PCN – Product Change Notification

PCN-A-1011109

PCN Topic: Winmate W32L300-OFA3 Power Module & Dimension changes

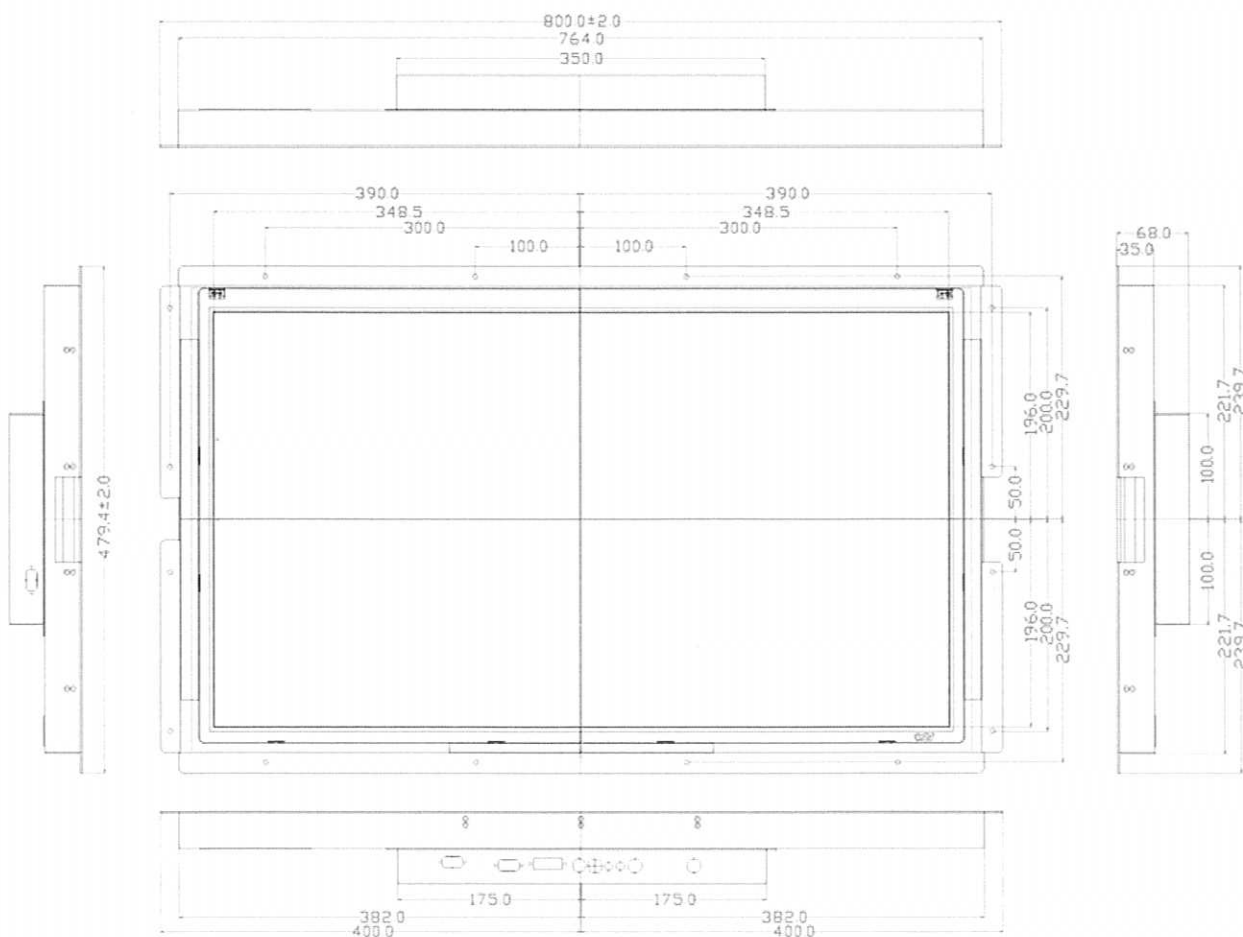
The power module of winmate W32L300-OFA3 will be changed from built-in module to external AC to DC Adapter.

New Chassis Drawing: (with External AC to DC adapter)

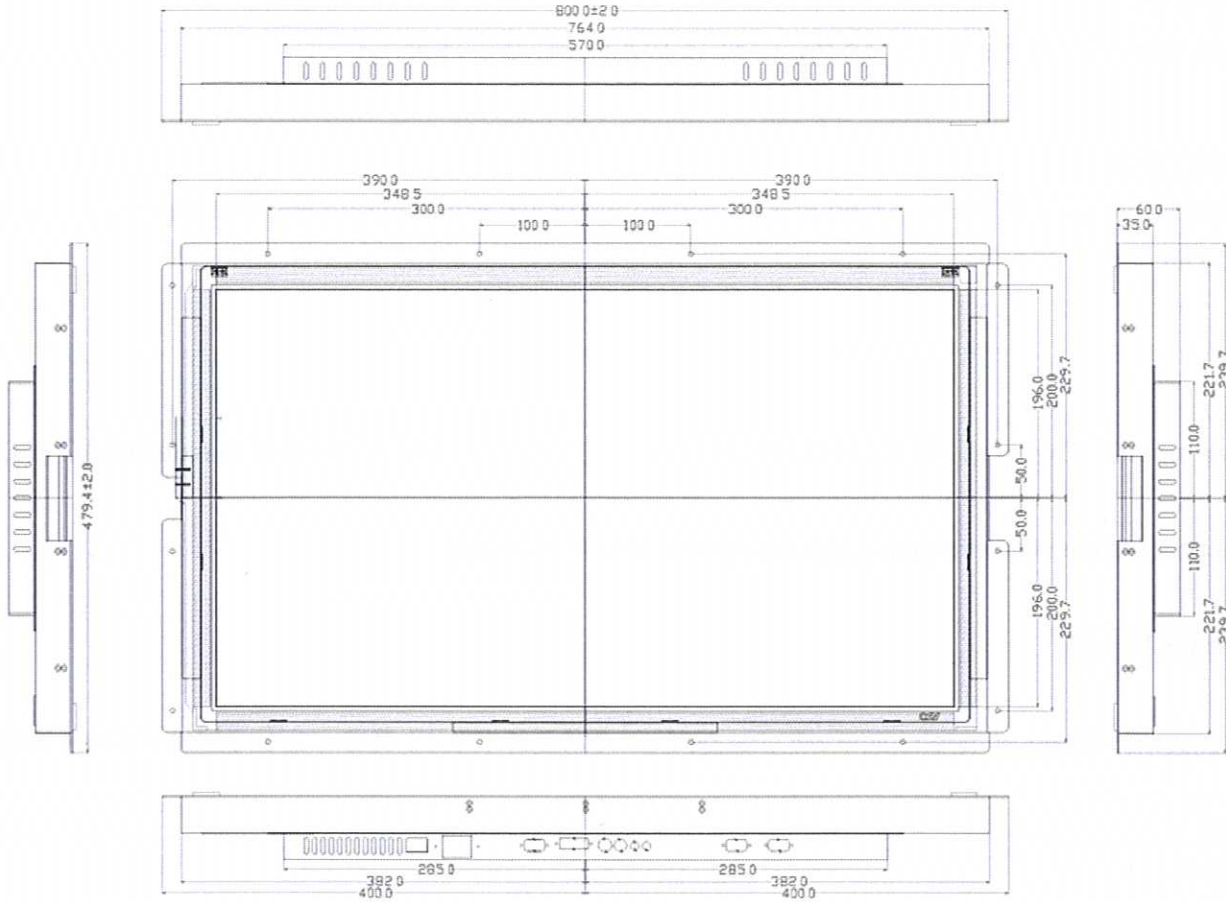
The dimension of **Chassis** mechanical will change from **800.0 X 479.4X 60.0** mm to **800.0 X 479.4 X 68.0** mm.
